Table 1 – Response to Additional Information Requested

### **RESPONSE TO REQUEST FOR ADDITIONAL INFORMATION – DA 240159**

Premise have prepared this letter on behalf of ACEnergy Pty Ltd to respond to a request for additional information (RFI) issued by Yass Valley Council (YVC) via the NSW planning portal on 25 October 2024. The request is made in respect of development application (DA) 240159 and relates to the proposed development of Murrumbateman Distribution Battery Energy Storage System (D-BESS) at 3 Turton Place, Murrumbateman.

Figure 4: Proposed acoustic barrier arrangement

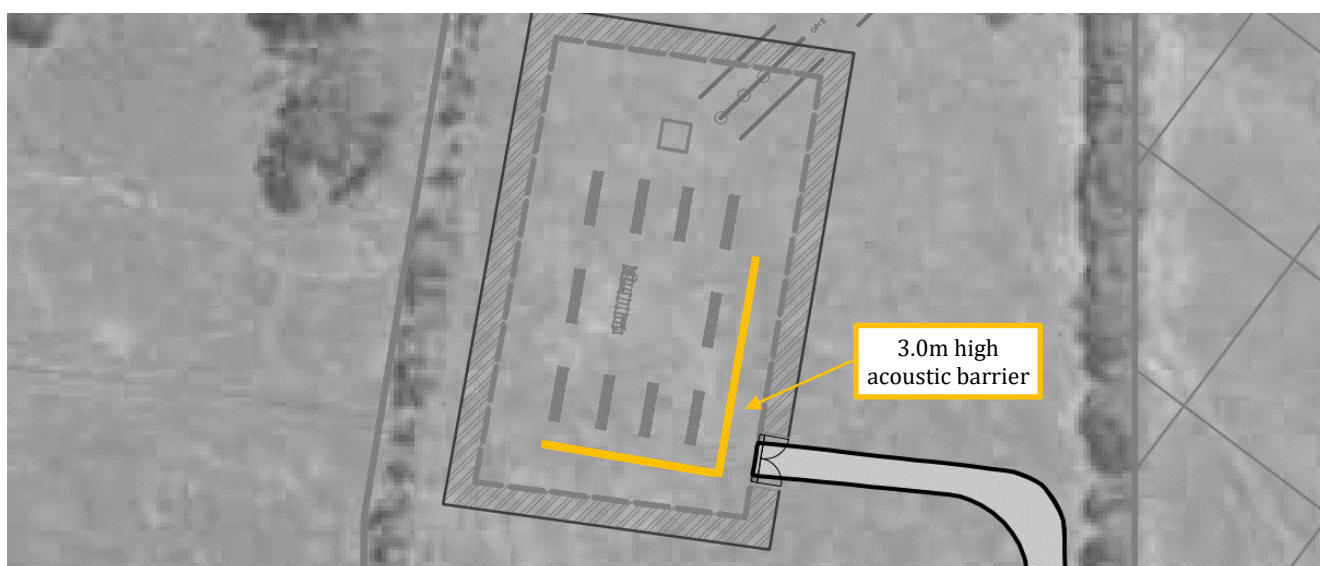
2.	<p><b>Acoustic Barrier</b></p> <p><i>The response to additional information request indicates that the revised acoustic report provides an indication of the general specifications for the proposed acoustic barrier, including minimum height of 3000mm and the general surface density. It is considered that there remains insufficient clarity and detail of the acoustic barrier to enable full assessment of this in accordance with s4.15 Environmental Planning and Assessment Act 1979. In this regard, the following information is to be provided:</i></p>	<p>The revised acoustic report (<b>Attachment 3</b>) has provided additional clarification on the construction of the barrier and specifications to ensure suitable materials are selected. The proposed acoustic barrier as specified by the acoustic assessment is to be constructed with:</p> <ul style="list-style-type: none"> <li>A minimum height of 3000mm. Noting that minor increases to the final height may result according to the assembly of panels.</li> <li>A surface minimum weight of 12 kg/m<sup>2</sup></li> <li>No gaps between panels and between the panels and the ground below.</li> </ul> <p>The acoustic barrier must be lined on the equipment side using sound absorbing materials, and WMG have recommended that:</p> <p><i>“...the absorption coefficient performance of the sound absorbing lining achieve not less than 0.9 at the 3150Hz one third octave band frequency which has been identified as critical to the assessment. The overall NRC performance can be lower, and in the order of 0.7.”</i></p>

*It is considered that there remains insufficient clarity and detail of the acoustic barrier to enable full assessment of this in accordance with s4.15 Environmental Planning and Assessment Act 1979. In this regard, the following information is to be provided:*

Additional Information Requested	Comments
	<p>From experience WMG detail that a suitable material for external applications may include Megasorber faced with Soundmesh G8 facing The technical specification sheet for the Soundmesh G8 facing material and other soundproofing products are available via <a href="#">Megasorber's website</a>.</p> <p>The final selection of soundproofing products is subject to the finalisation of design. Several options, however, are available and are capable of being designed to achieve the requirements of the project.</p> <p>The applicant has no objection to a condition of consent requiring the provision of this information to Council's satisfaction prior to issue of a construction certificate.</p>
<ul style="list-style-type: none"> <li><i>Separate, dimensioned, elevation drawings of the acoustic barrier, including the maximum height and details of construction type, material, and colours/finishes are to be provided.</i></li> </ul>	<p>A revised drawing set, including details of the proposed acoustic barrier, is provided as <b>Attachment 2</b>. This includes a typical section of the proposed barrier, features of the material proposed and elevations.</p> <p>As noted, final details on the construction type, material, colours and finishes of acoustic products are contingent on the selection of vendors during the detailed design stage. <a href="#">Megasorber's website</a>, however, provides example specification sheets for suitable acoustic products which include dimensions of panels, acoustic properties and options for colours and finishes.</p>

<ul style="list-style-type: none"> <li><i>Site plan with clear dimensions for lengths and relative setbacks,</i></li> </ul>	<p>The revised drawing set (<b>Attachment 2</b>) includes an updated site plan to respond to council's request.</p>
<p>3. <b>Materials &amp; Colours</b></p> <p><i>It is noted in the record of briefing that the Panel considered that visual impacts could be reduced through the use of appropriate materials and colours. In this regard, details of materials and colours are to be provided and should be:</i></p> <ul style="list-style-type: none"> <li><i>Compatible and sympathetic to the surrounding development.</i></li> <li><i>Non-reflective.</i></li> </ul>	<p>The final selection of project infrastructure, including materials and colour for project infrastructure (e.g., batteries and acoustic products), is dependent on the options available during the finalisation of detailed design and the selection of vendor products for the construction of the project. Where possible, suitable materials and finishes would be implemented to minimise the potential for perceived visual effect, and the longevity of materials and durability of the same. A consent condition for the provision of a final schedule would be a practical measure.</p> <p>The applicant has no objection to a condition of consent requiring the provision of this information to Council's satisfaction prior to issue of a construction certificate.</p>
